Proposal for amendments to ECE/TRANS/WP.29/GRSP/2014/28

Proposal for the 01 series of amendments

Submitted by the expert from France

The text reproduced below was prepared by the expert from France. It introduces the amendments to UN Regulation No. 129 (Enhanced Child Restraint System (ECRS)) that were agreed upon by the experts of the Informal Working Group on Child Restraint Systems (IWG CRS) in Phase 2 of the UN Regulation and extends the scope of the Regulation to Non-Integral child restraint systems ("Universal Booster" or "Specific to vehicle Booster"). On the basis of ECE/TRANS/WP.29/GRSP/2014/7, it incorporates changes agreed upon at the last meetings of the IWG CRS and on GRSP-55-08 distributed at the fifty-fifth session of Working Party on Passive Safety (GRSP) (ECE/TRANS/WP.29/GRSP/55, para. 29). The modifications to the existing text of the UN Regulation are marked in bold for new or strikethrough for deleted characters. [The reference document was the original UN Regulation No. 129, Corrigendum 1 and Supplements 1, 2 and 3.](#)

Figure 1
Dimensions in mm of the seat and the seat cushions

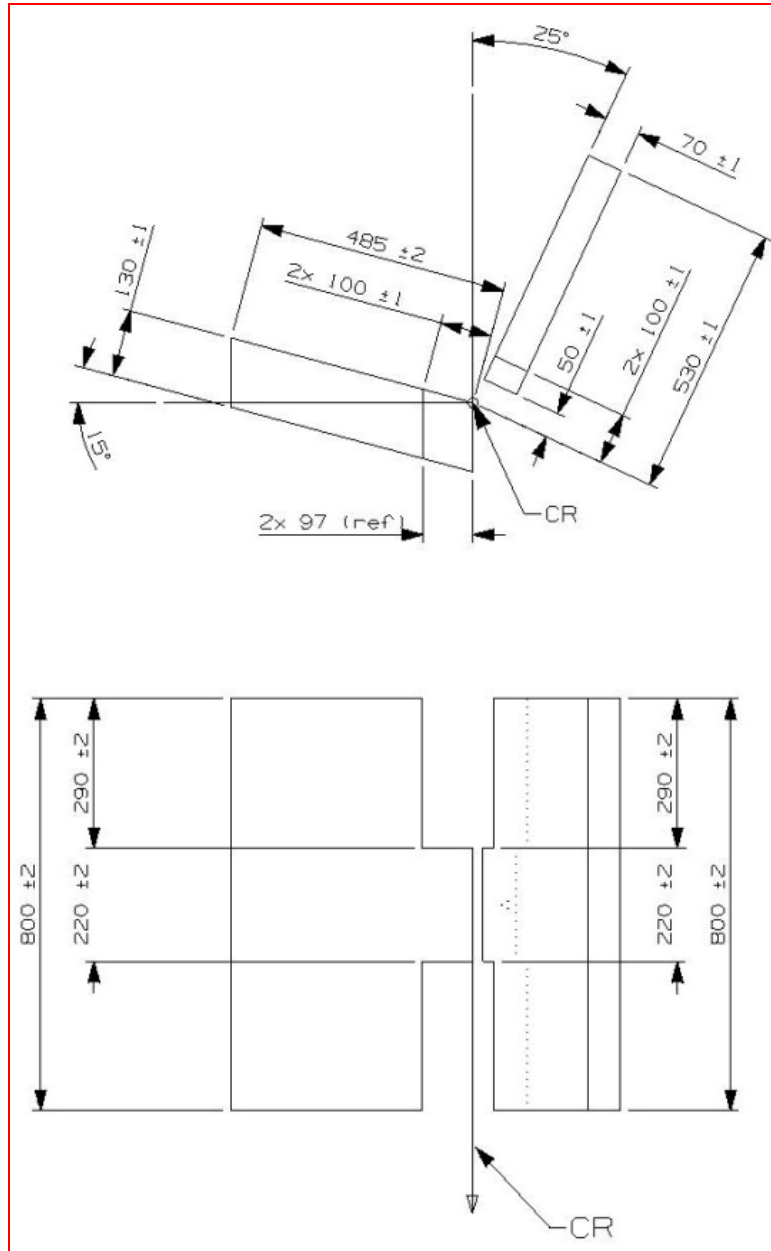
Annex 6, paragraph 3.1.2., amend to read:

"3.1.2. Rigid seating, **made from a rigid metal sheet**, dimensions of which are given in Appendix 1 to this annex. ~~The rear part of the seating is made from a rigid sheet metal. The front part of the seating is also made of a 20 mm diameter tube;~~"

Figure 1
Door
and
- Top

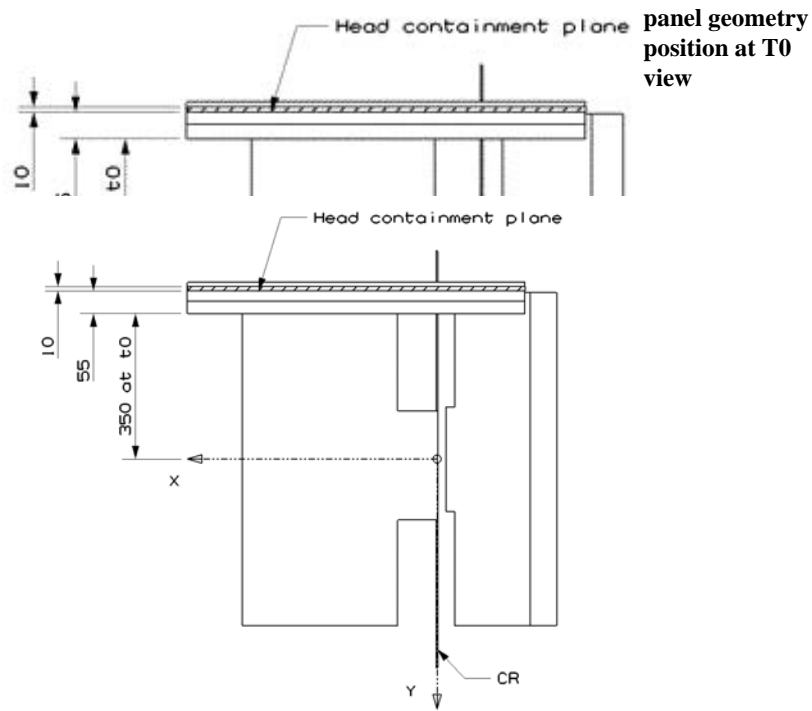
The impact surface of the door panel shall be entirely covered with a padding material of 55 mm in thickness (see Figure 1 above). The material shall comply with the performance criteria specified in paragraph 2.3. (figure 4 below) of this appendix when tested in accordance with paragraph 2.2. of this appendix.

Figure 4
Corridor for the padding material

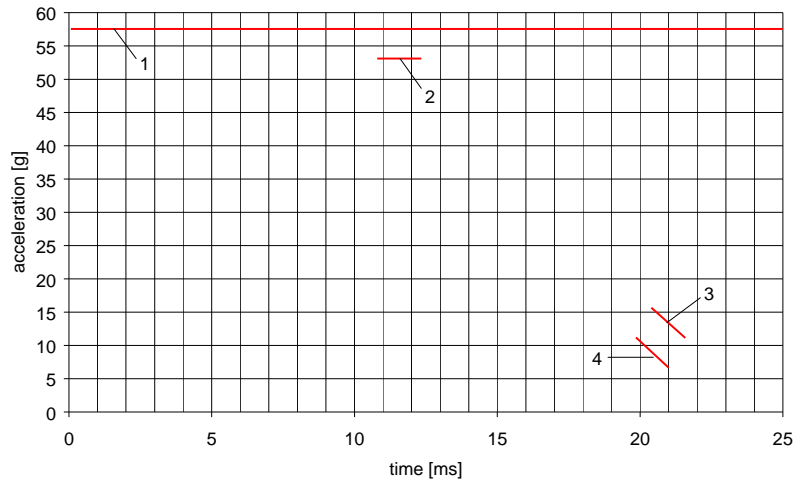
The time of first contact between sample material and head form (t_0) is 0 ms.

The impactor acceleration shall not exceed 58 g.

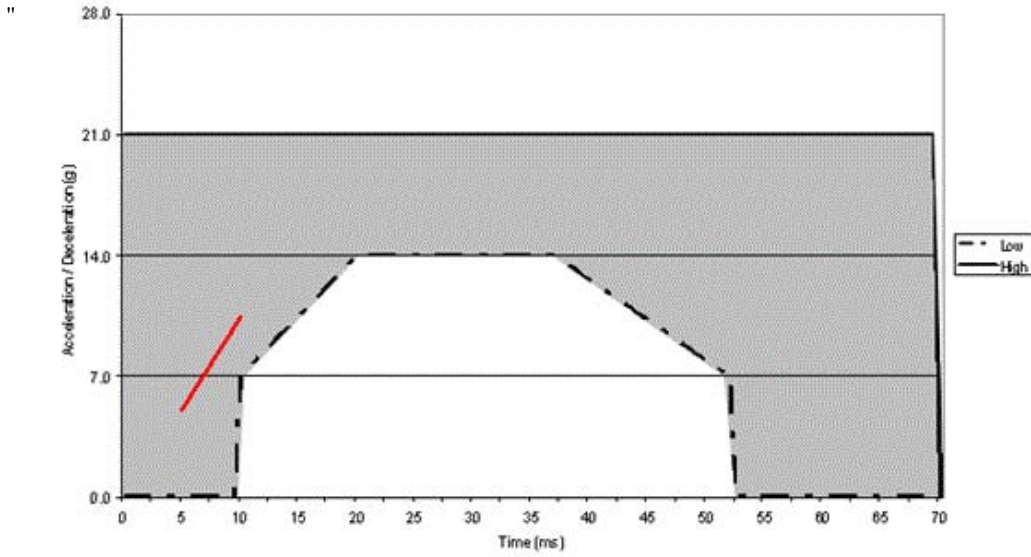
Annex 7, Appendix 1, the figure, amend to read:

Figure 1

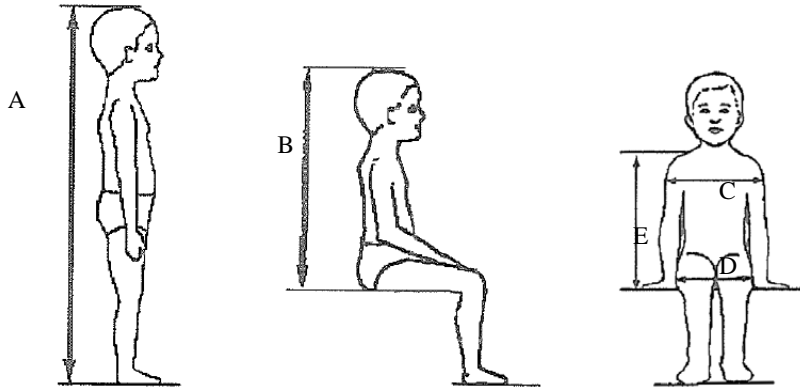
~~When~~ **All lateral dimensions are** measured under a contact force of 50 N with the device described in Figure 2 of this annex **and** the following tolerances will ~~be applied to the dimensions:~~

Figure 1
Standard seat belt configurations

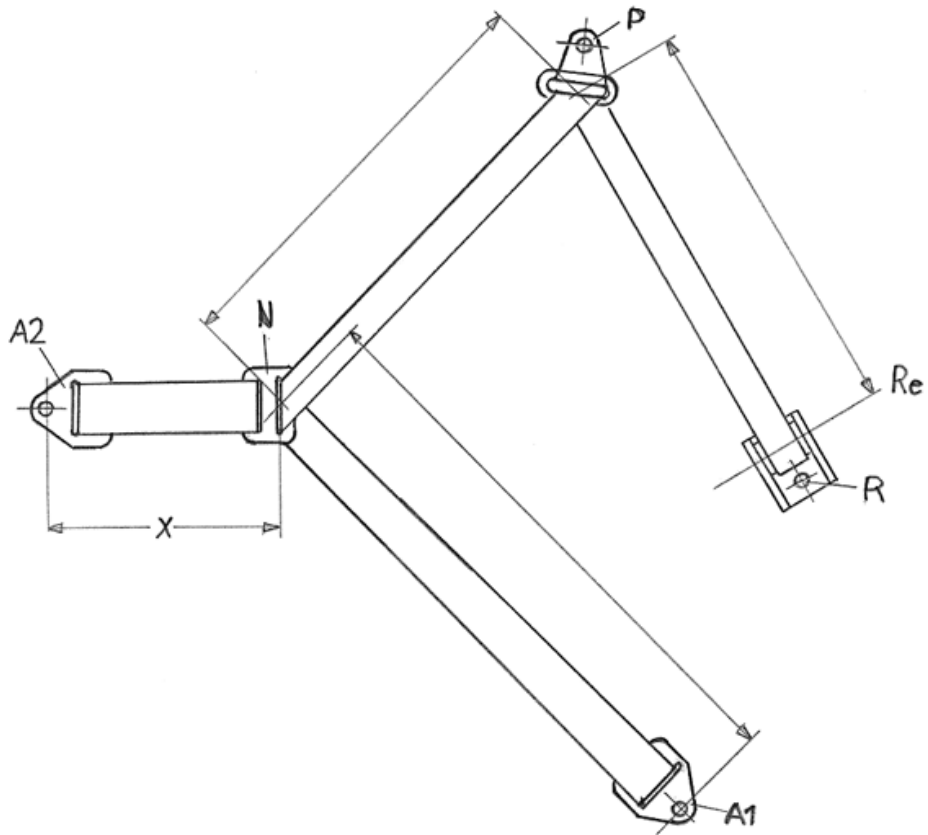
1. The safety-belt for the dynamic test and for the maximum length requirements shall be made according to one of the two configurations shown in Figure 1. These are a three-point retracting belt system.

2. The three-point retracting belt has the following rigid parts: a retractor (R), a pillar loop (P), two anchorage points (A1 and A2) (see Figure 1), and a central part (N, in detail in Figure 3). The retractor shall comply with the requirements of Regulation No. 16 (paragraph 6.2.5.2.2.) for retraction force. The retractor spool diameter is 33 ± 0.5 mm (example is given in Mutual Resolution No. 1 (M.R.1)).

The value of X in Figure 1 below is 200 ± 5 mm. The effective strap length between A1 and the centre line of the retractor spool Re (when the webbing is fully extracted including the minimum length of 150 mm for testing of Enhanced Child Restraint System shall be $[2820] \pm 5$ mm when measured in a straight line without load and on a horizontal surface. This length may be increased for the testing of restricted categories; for all categories with the Enhanced Child Restraint System installed, there shall be a minimum of 150 mm of strap length on the retractor spool.
4. The strap requirements for the belt as follows:
 - (a) Material: polyester spinnblack;
 - (b) Width: 48 ± 2 mm at 10,000 N;
 - (c) Thickness: 1.0 ± 0.2 mm;
 - (d) Elongation: 8 ± 2 per cent at 10,000 N.

Figure 1. Measuring Device for a Universal Booster Cushion

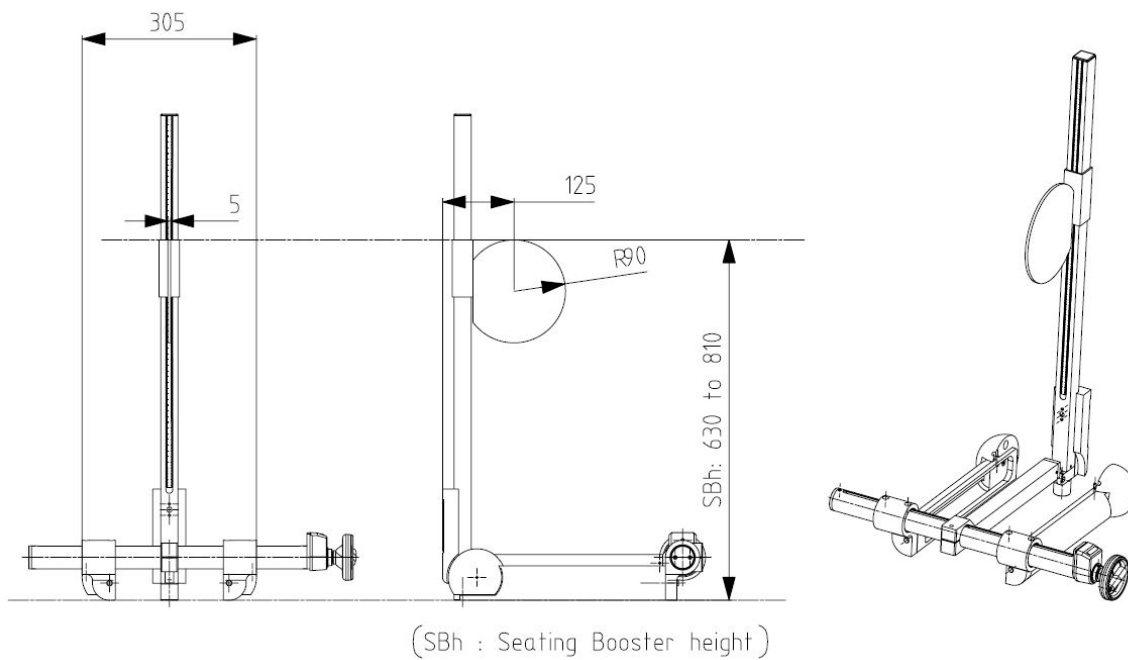
The measuring device to assess a universal Booster Cushion is described Figure 1. This measuring device shall have a mass of 10 ± 1 kg.

Figure 2 – Installation of the Measuring Device to measure Z5 and Z95

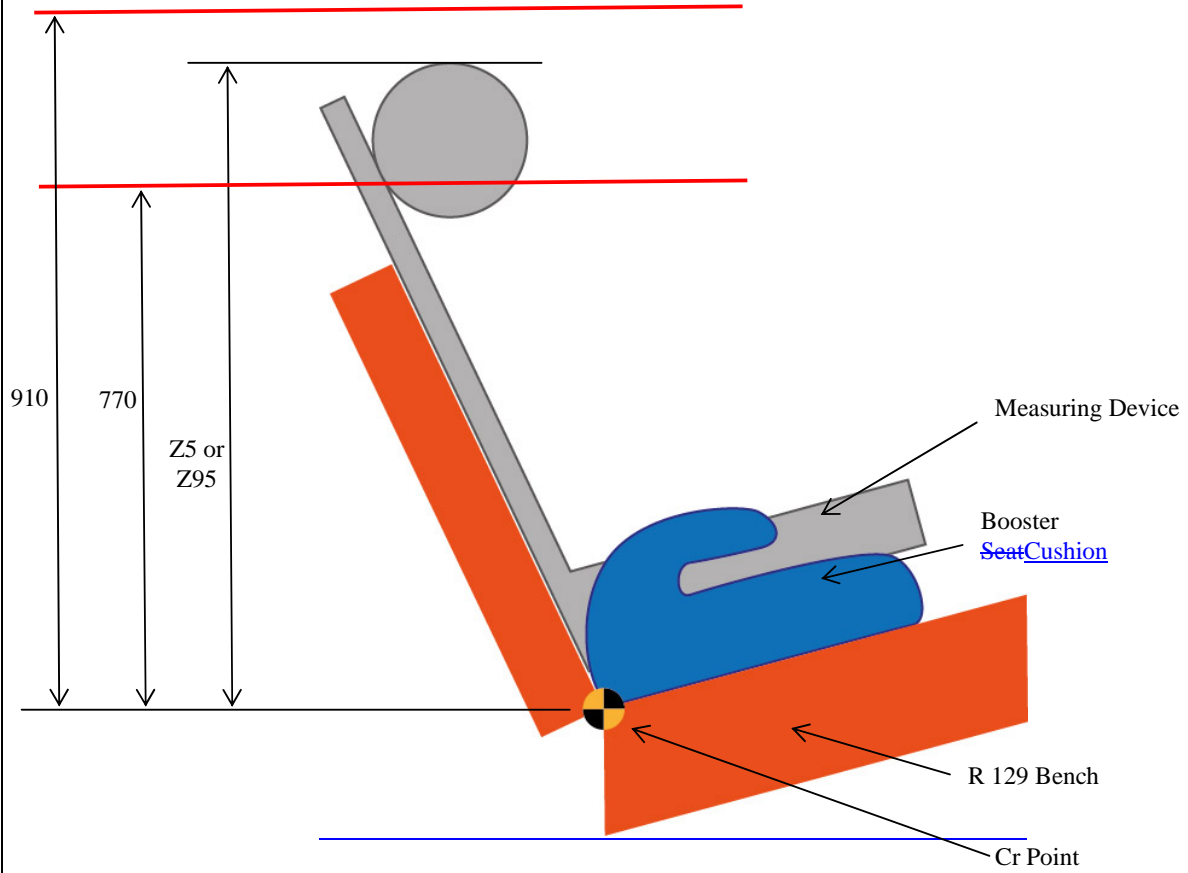
2.3. Position the Booster Measuring Device on the Booster Cushion as defined in Figure 2
